## Service Bulletin 4812 718 40305

**TITLE:** Condensation

**SUBJECT:** Condensation on kitchen furniture, kitchen worktop, control panel in combination with DW POINT appliances

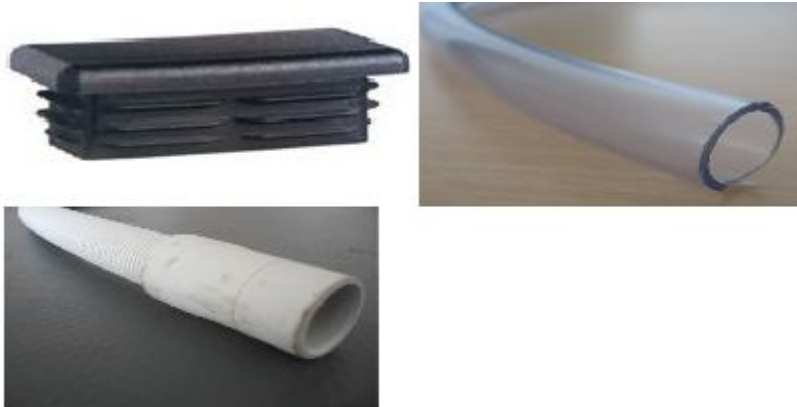
For cases where the steam escapes from the door area, there is the following procedure possible:

**Removing of the insulation in the front third - also on the side**

**Shortening of the upper insulation by one third (ca. 10cm)**

**Close gap between inner/ outer door, between outer door/ control panel  
and between inner door/ control panel with silicon**

**REF: Door hook – Condensation issue**

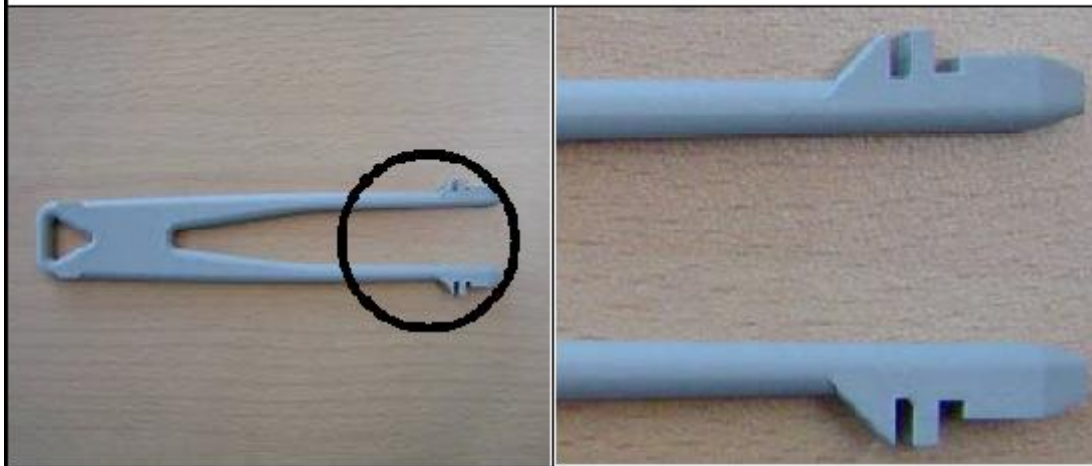
Due to tolerances in production, there could be the case, that the door doesn't close properly, which leads to out coming steam, loud noise or clear hearable hydraulic work and condensation under the worktop in the kitchen.

There is a service solution available for these cases

**Spare part number 4812 401 18887**

Position to tighten the closure of the door

Normal position

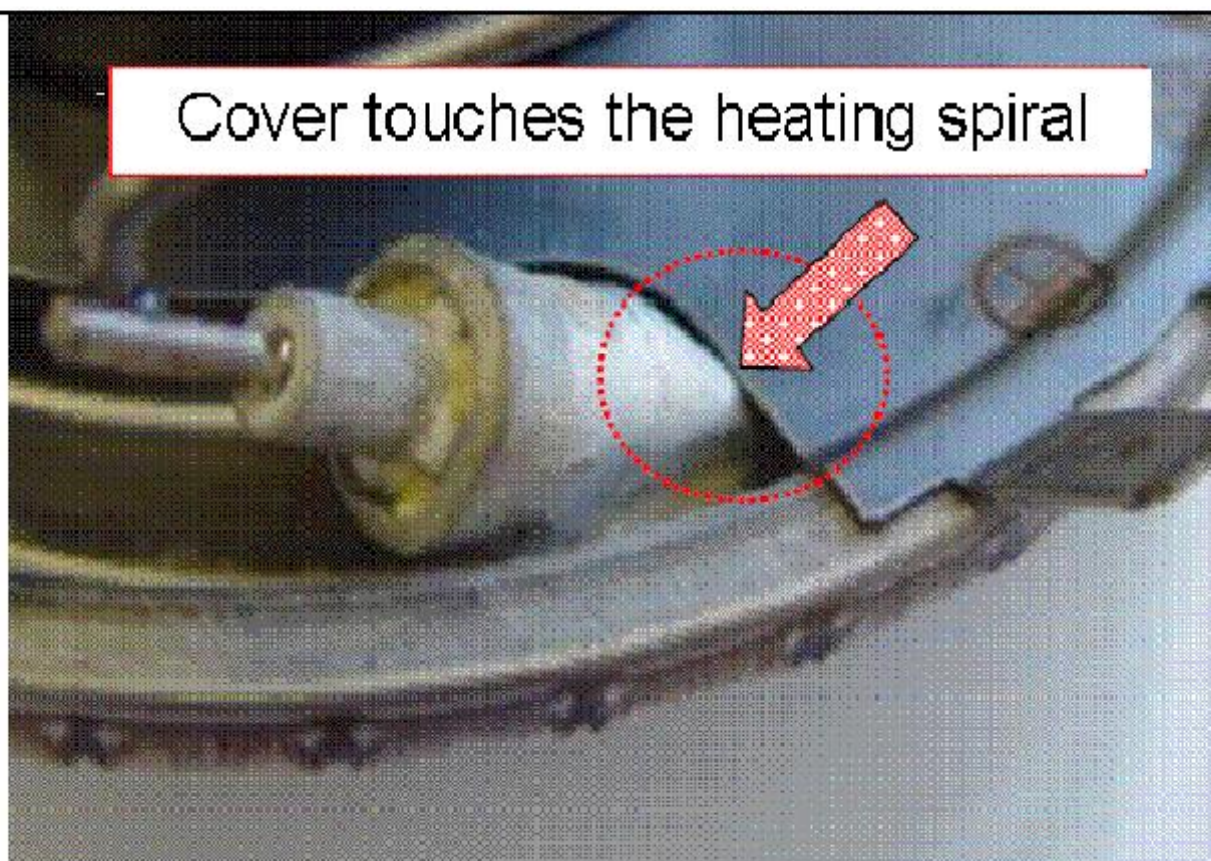
Under certain circumstances the distance between the wiring of the heater coil and the rubber part is too less. This lead to a creeping current circuit between the heater wiring and the rubber tube.

- Check during every intervention if the position of the heater wiring is correct.
- Realign the position that the wiring is parallel to the heater metal sheel.

**Wrong**

**Correct**

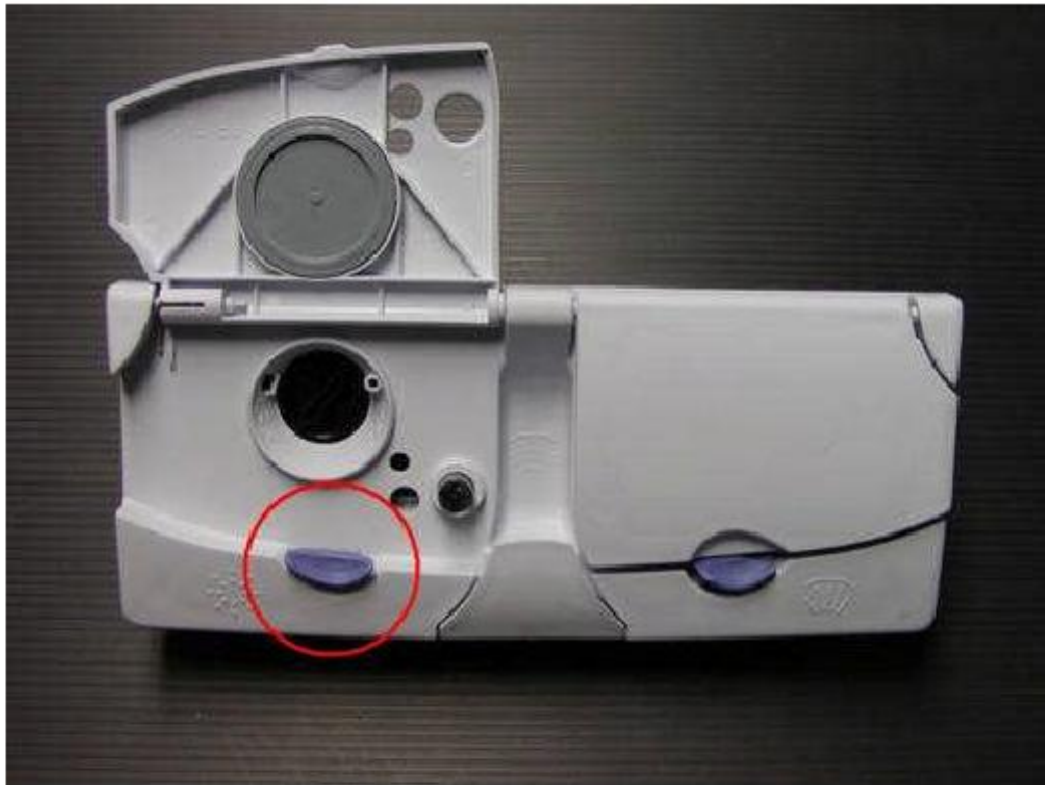
Due to the production process at the supplier of the integrated heating module, there is the possibility, that the cover touches the heating spiral. This could lead to a noise during the heating phase in a wash program at a defined speed.

To solve the issue, bend the cover in this area very carefully a little bit (see second picture) to ensure, that the heating spiral isn't touched by the cover.

**Wrong alignment**

**Correct alignment**

The version Aweco with blue socket.

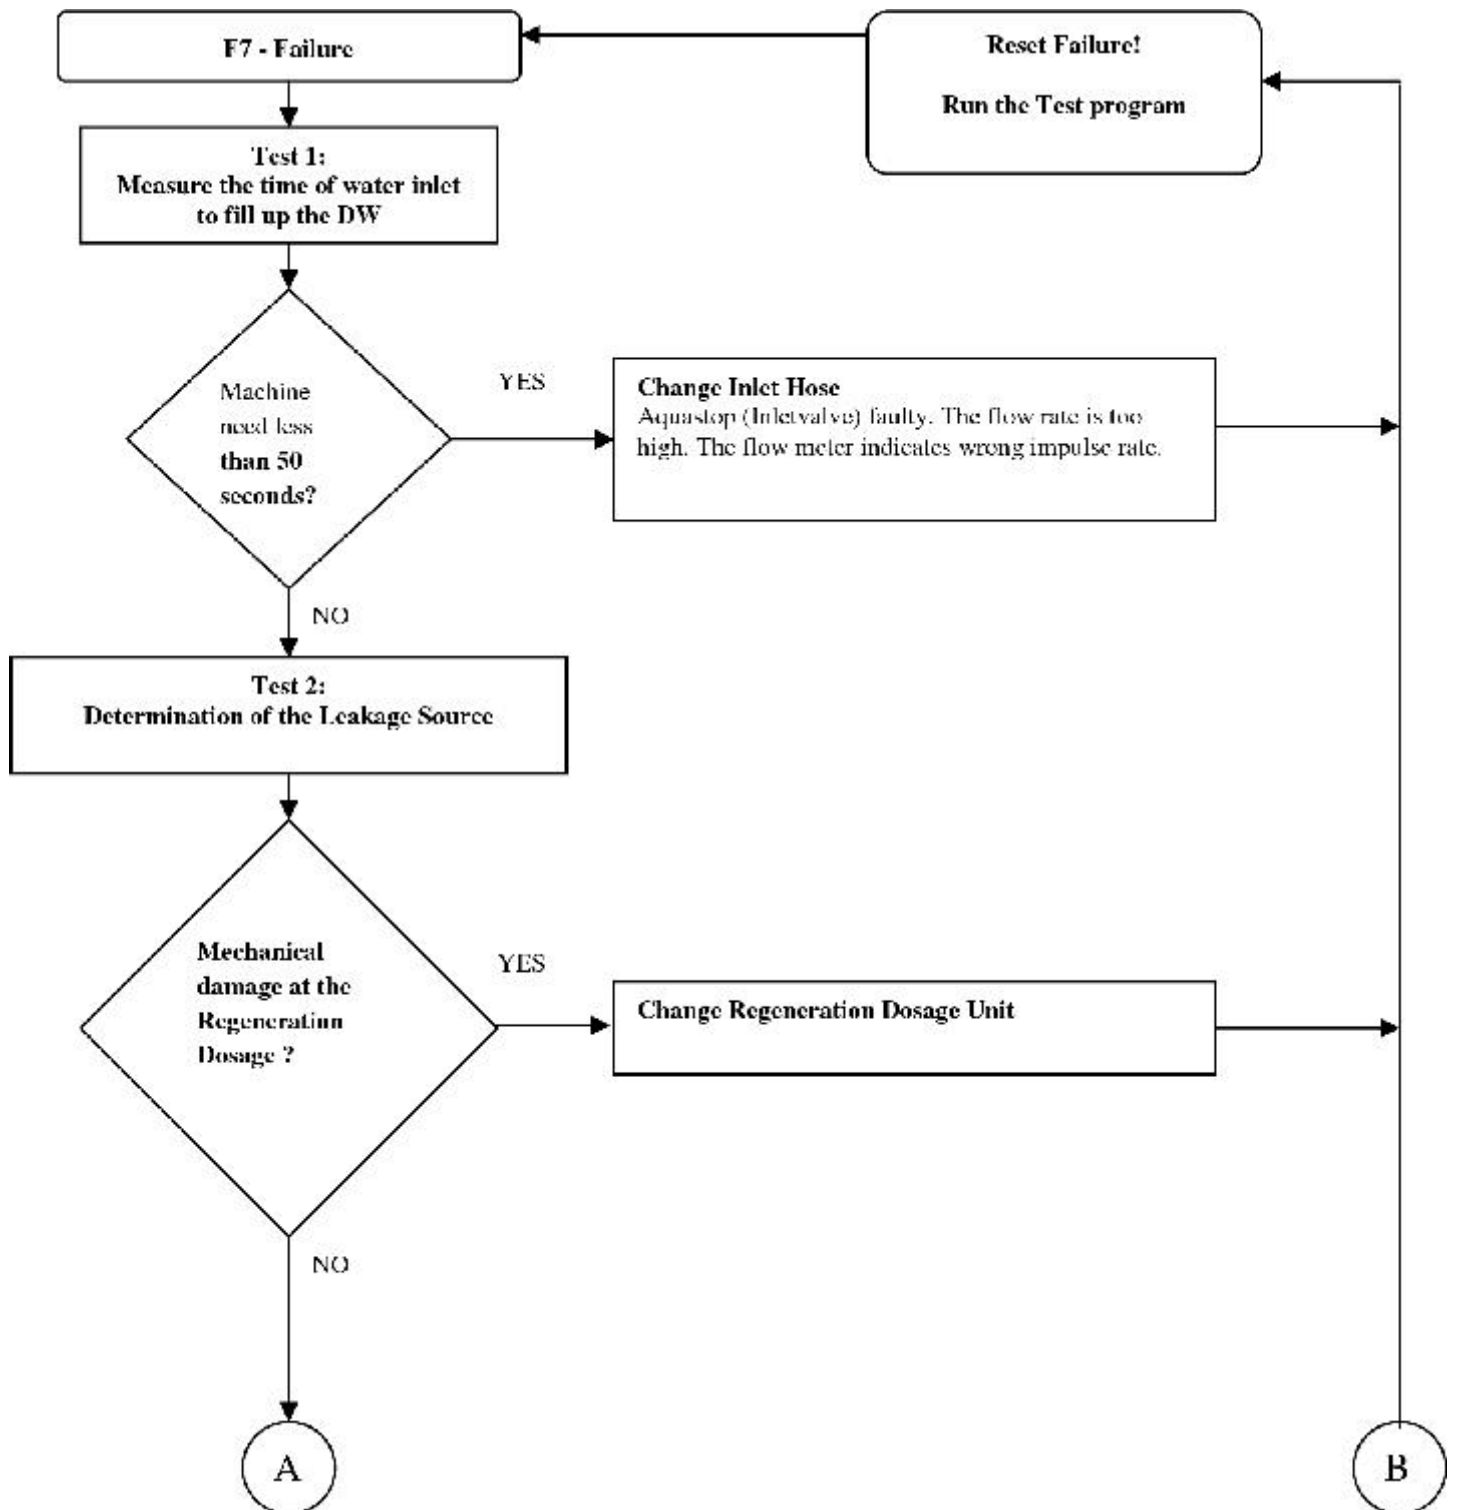
The Point range dishwashers are built with two different versions of regeneration dosages and different flow meters inside.

As Service solution you can order both Flow Meters as Service Kit in one packaging:

Service Part 12NC for both reedcontact PCB's : 4812 310 19147

NO MORE AVAILABLE

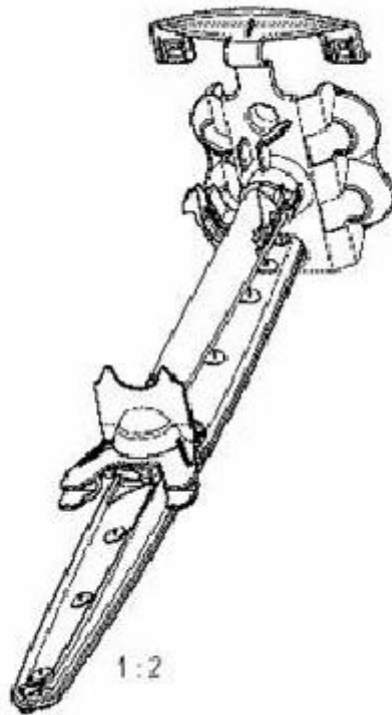
Due to the fact that the single spray arm won't be available as single part you have to order the complete 2nd level water support.

Please order instead of the Single Spray Arm

**4812 718 40196****REF: Internal leakage at the nozzle plate****Model: Point dishwasher**

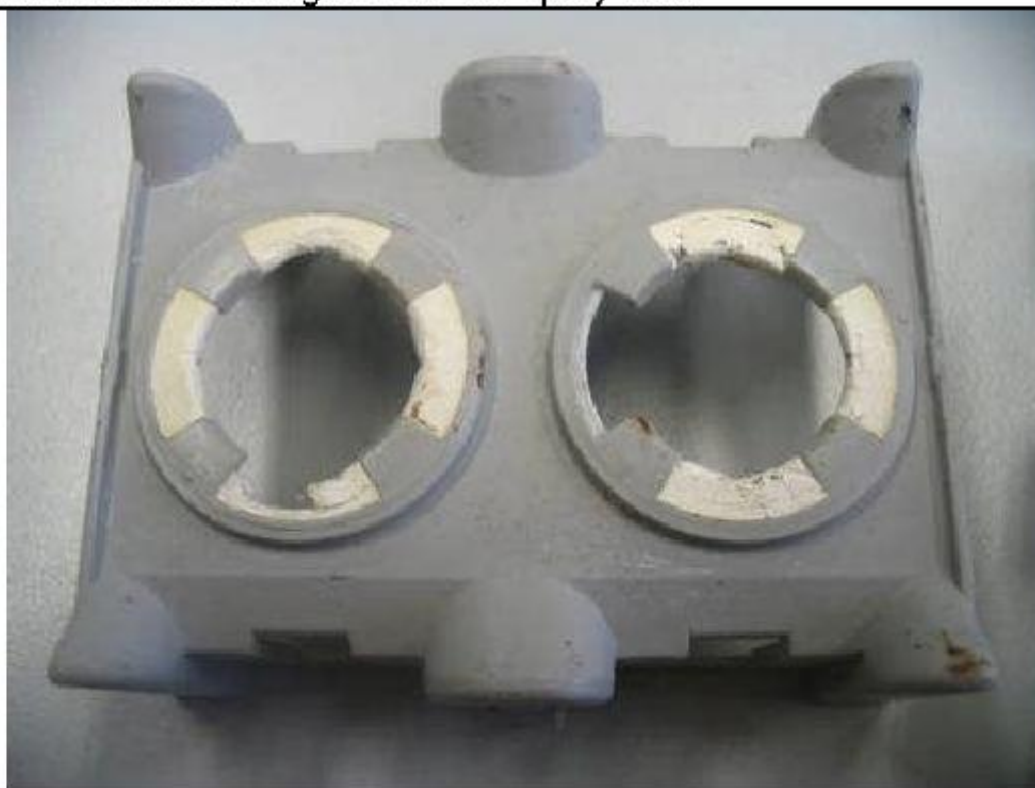
The elastic plastic part of the nozzle unit wear out and lead to internal leakage.  
A part of the water won't be guided to the spray arm.

Exchange the nozzle plate

- Take the main tube free on the metal clips.
- Then dismantle the nozzle plate from the main tube with slight pressure from the plastic hooks.

**Service spare part 12NC for the single nozzle plate:  
4812 530 29431**
